ADDENDUM #1 04/01/2024
REVISED SHEETS: TITLE, D11, D12, D14, P1, P2, P4
REVISION #1 06/18/2024
REVISED SHEETS: TITLE, D8A(ADDED), P1-P4, P6, U5, U6, U10, W5, W6
REVISION #2 07/17/2024
REVISED SHEETS: TITLE, D8B(ADDED), D11, P1-P2, P5-P6, W3, MN1-MN2
REVISION #3 07/26/2024
REVISED SHEETS: TITLE, U2-U4, U7, U9, U11-U13, W2-W4, E1-E10
REVISION #4 08/15/2024
REVISED SHEETS: TITLE, D11, D12, P1, P2, U2-U4, U9, U10, U11, PM8, X3, X4
REVISION #5 08/26/2024
REVISED SHEETS: TITLE, U4, U9-U11, W4
REVISION #6 09/10/2024
EVISED SHEETS: TITLE, P5, U4, U8, U9, PM1-PM8

E. WILSON ST. AND E. DOTY ST. RECONSTRUCTION

CITY PROJECT NO. 11543
CONTRACT NO. 8735

11543
P-3

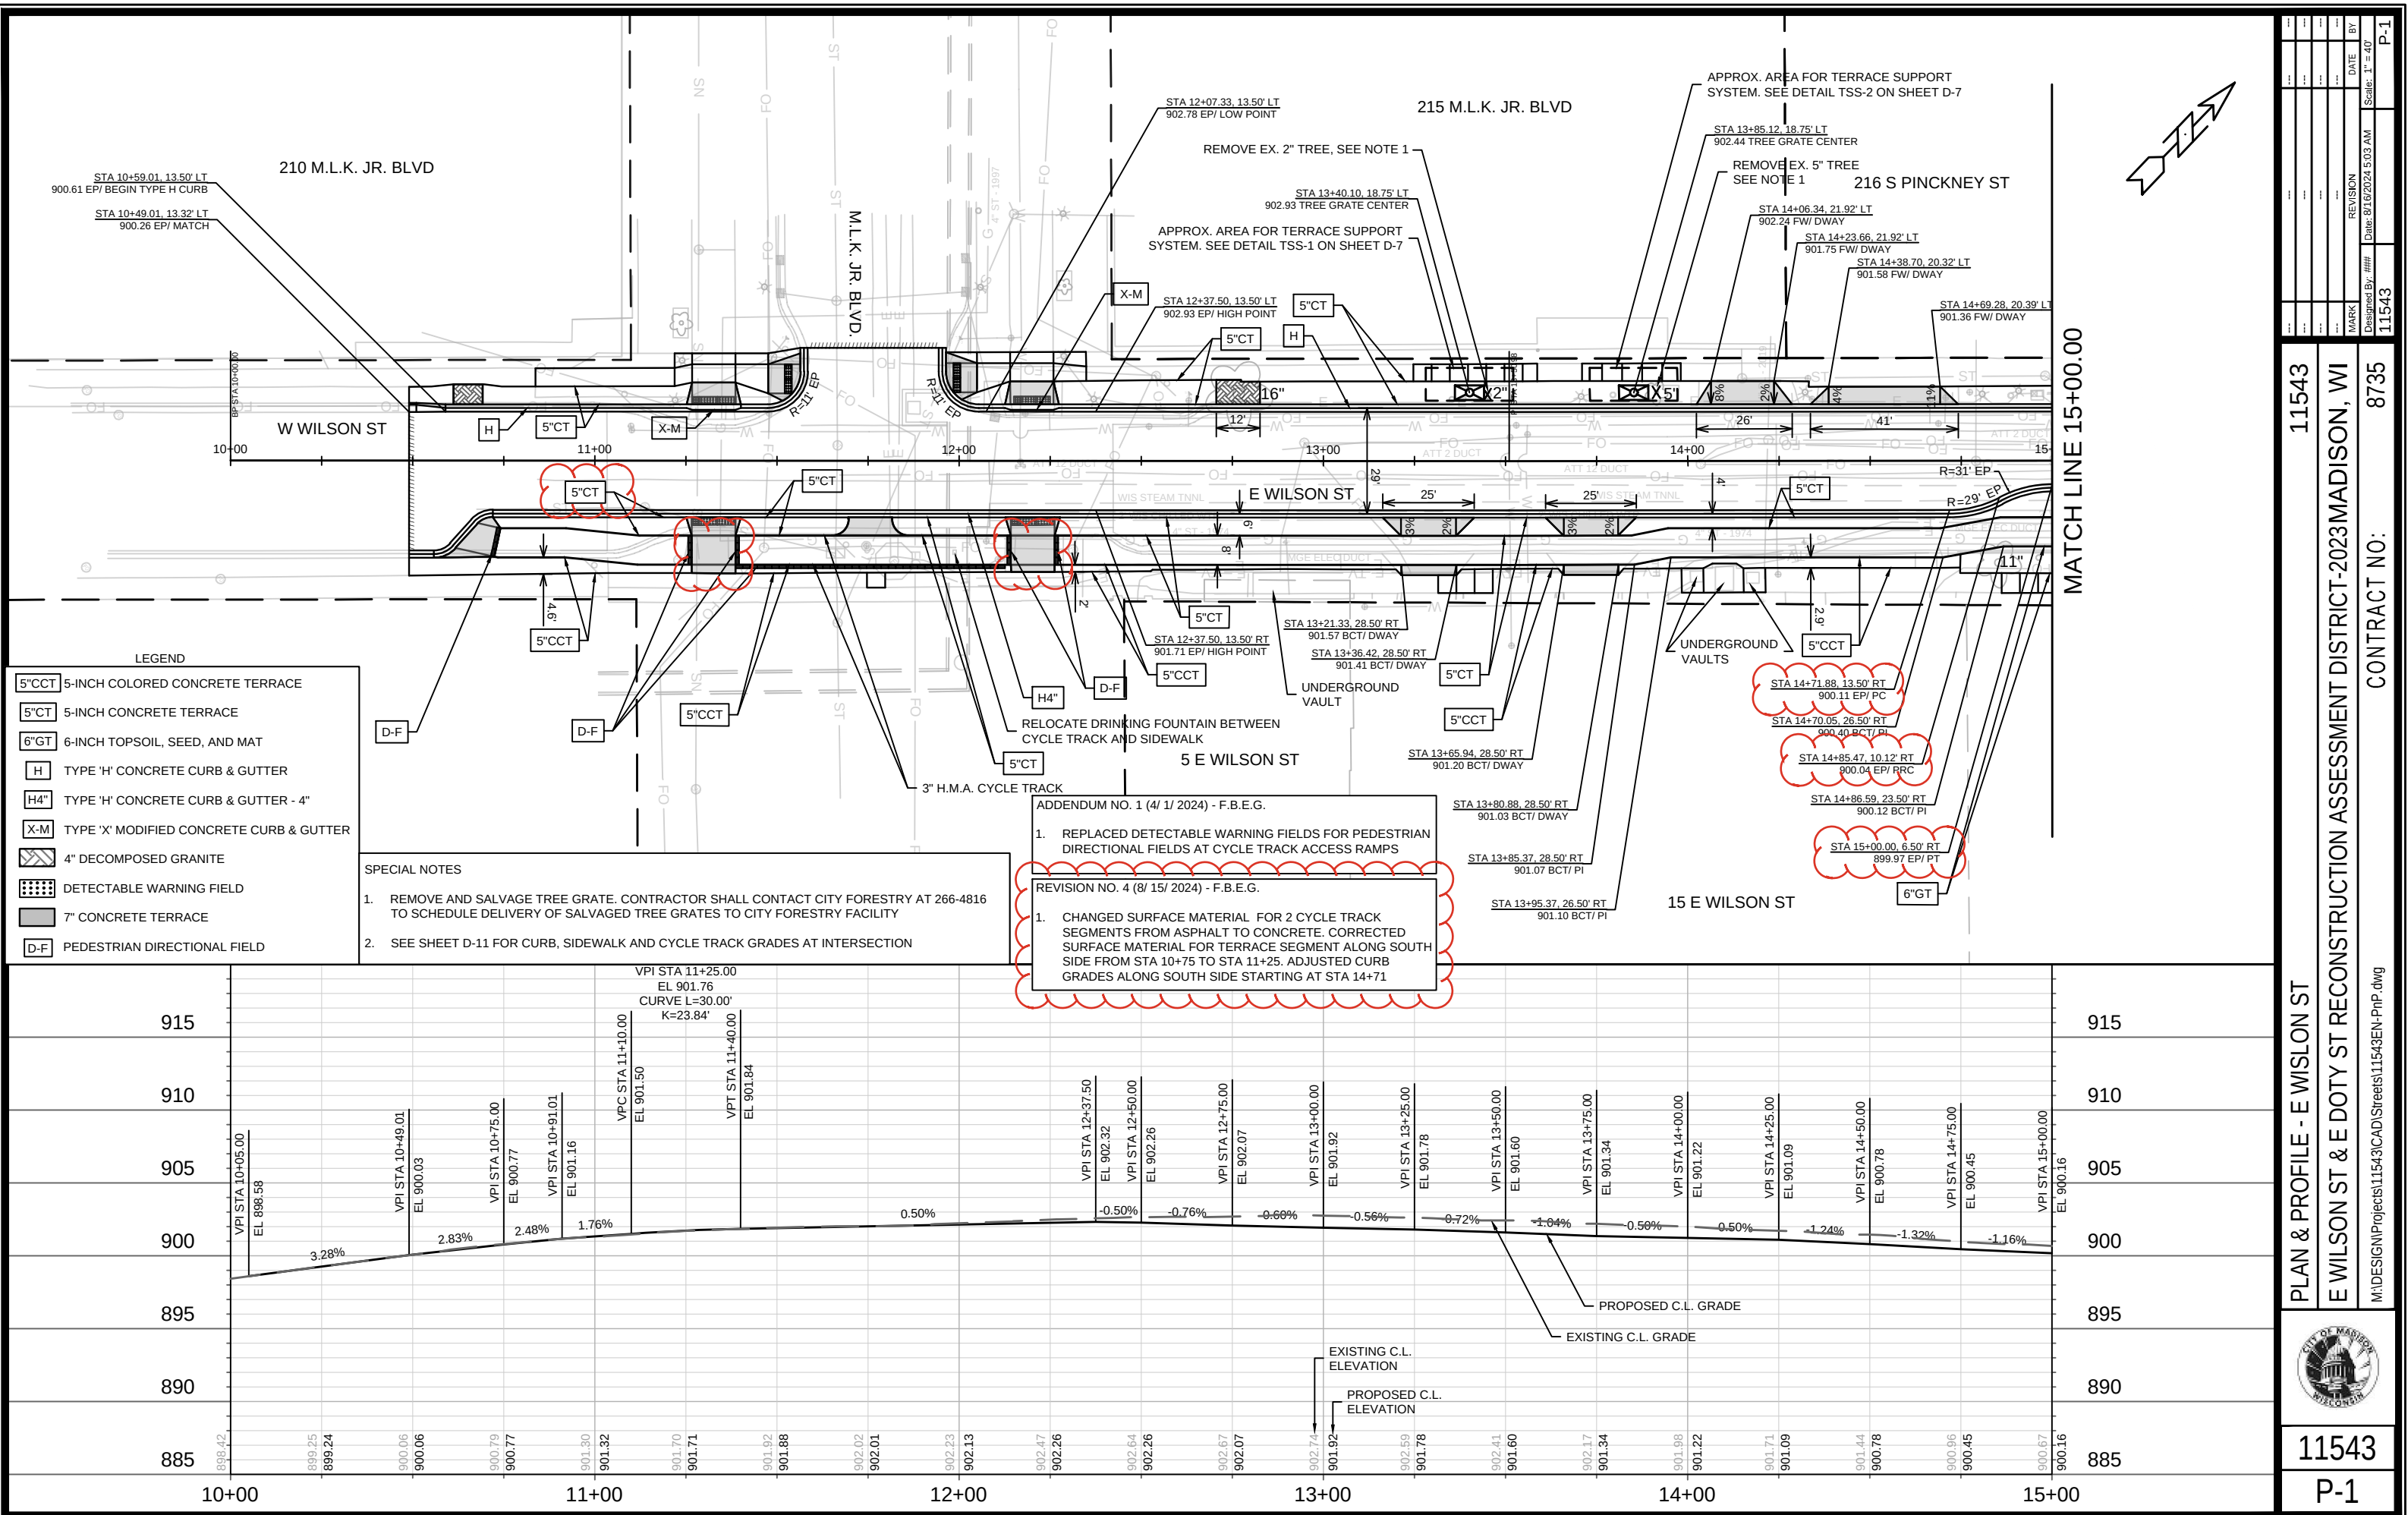
- REVISION NO. 7 (4/ 11/ 2025) - F.B.E.G.
1. ADDED 7" CONCRETE ALONG KING PAVEMENT TO REPLACED THE REMOVED CONCRETE MOUNTABLE MEDIAN.

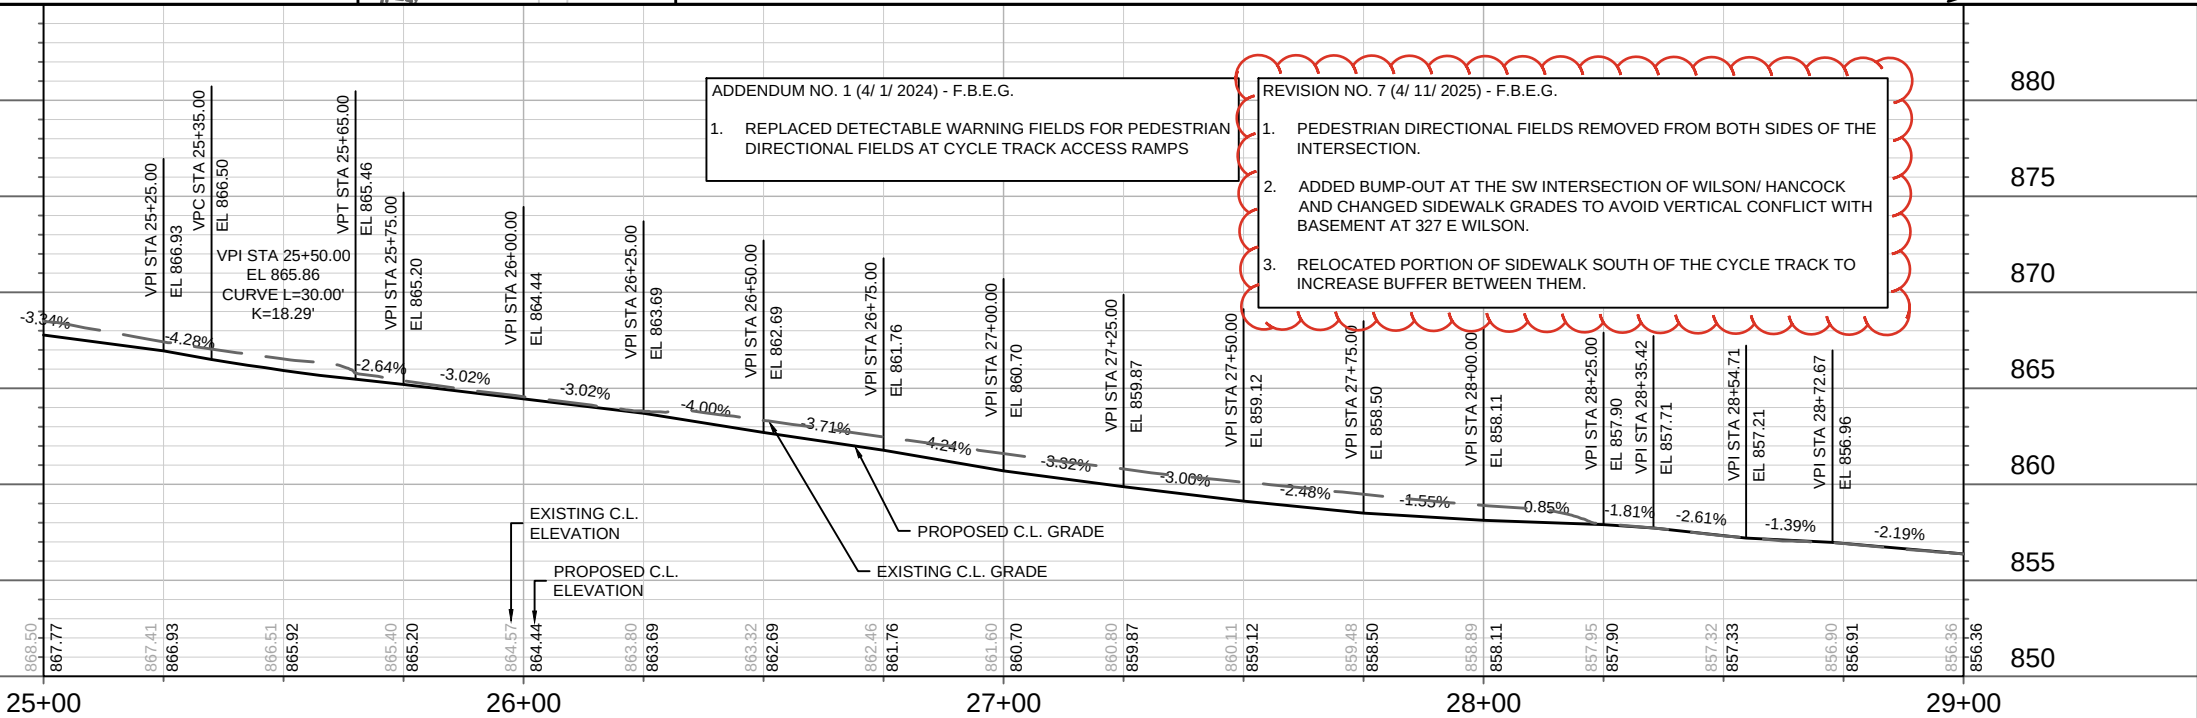
- ADDENDUM NO. 1 (4/ 1/ 2024) - F.B.E.G.
1. REPLACED DETECTABLE WARNING FIELDS FOR PEDESTRIAN DIRECTIONAL FIELDS AT CYCLE TRACK ACCESS RAMPS

- REVISION NO. 7 (4/ 11/ 2025) - F.B.E.G.
1. PEDESTRIAN DIRECTIONAL FIELDS REMOVED FROM BOTH SIDES OF THE INTERSECTION.
 2. ADDED BUMP-OUT AT THE SW INTERSECTION OF WILSON/ HANCOCK AND CHANGED SIDEWALK GRADES TO AVOID VERTICAL CONFLICT WITH BASEMENT AT 327 E WILSON.
 3. RELOCATED PORTION OF SIDEWALK SOUTH OF THE CYCLE TRACK TO INCREASE BUFFER BETWEEN THEM.

11543		WATER PLAN & PROFILE - E. WILSON ST	
E WILSON ST & E DOTY ST RECONSTRUCTION ASSESSMENT DISTRICT-2023MADISON, WI		11543	
CONTRACT NO: 8735		W-2	
M:\DESIGN\Projects\11543\CAD\Water\11543WUJ-PressureNetwork.dwg		11543	
11543		W-2

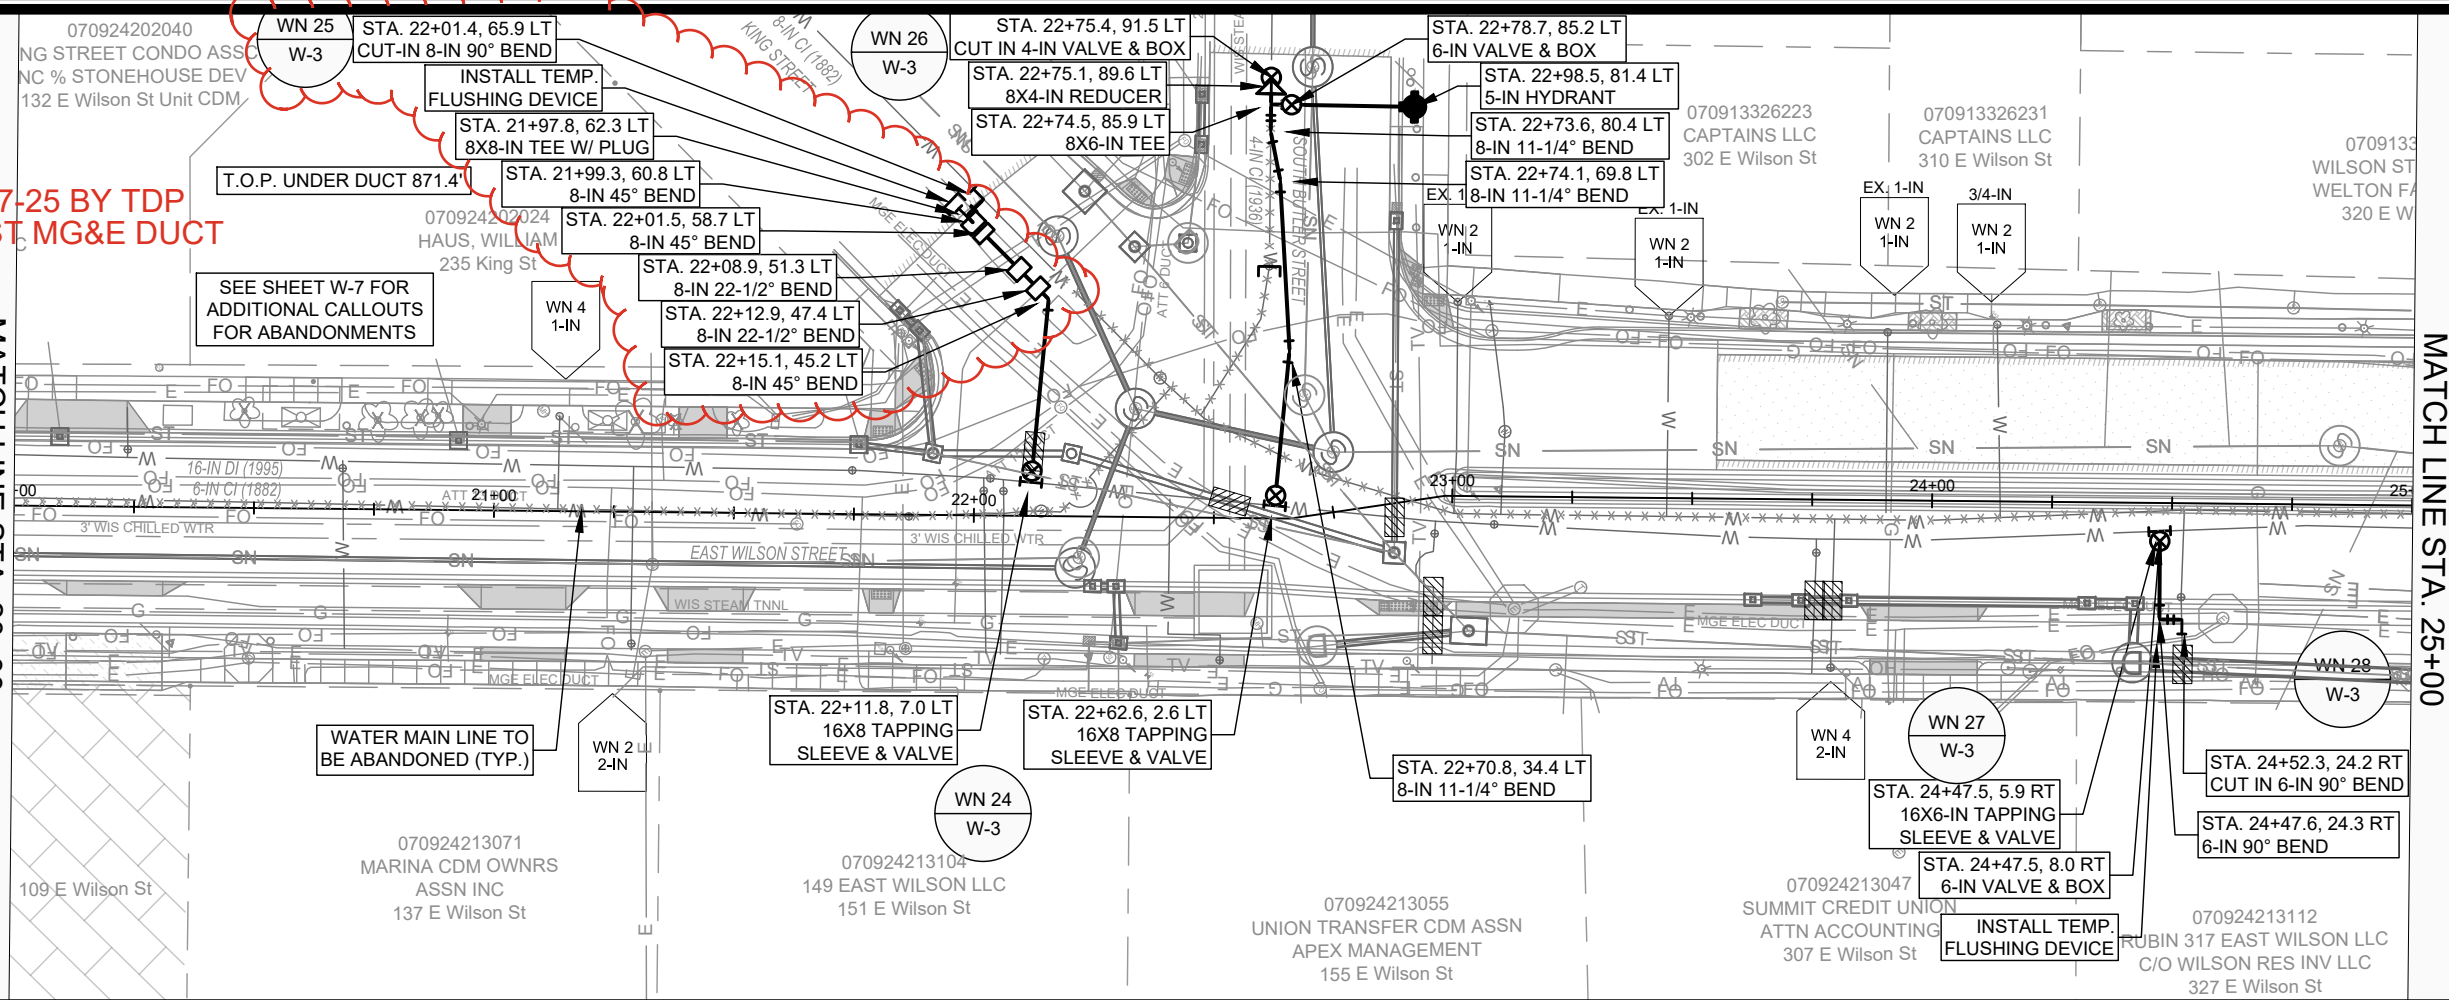
REVISED 2024-07-25 BY TDP
REVISED OFFSET MG&E DUCT
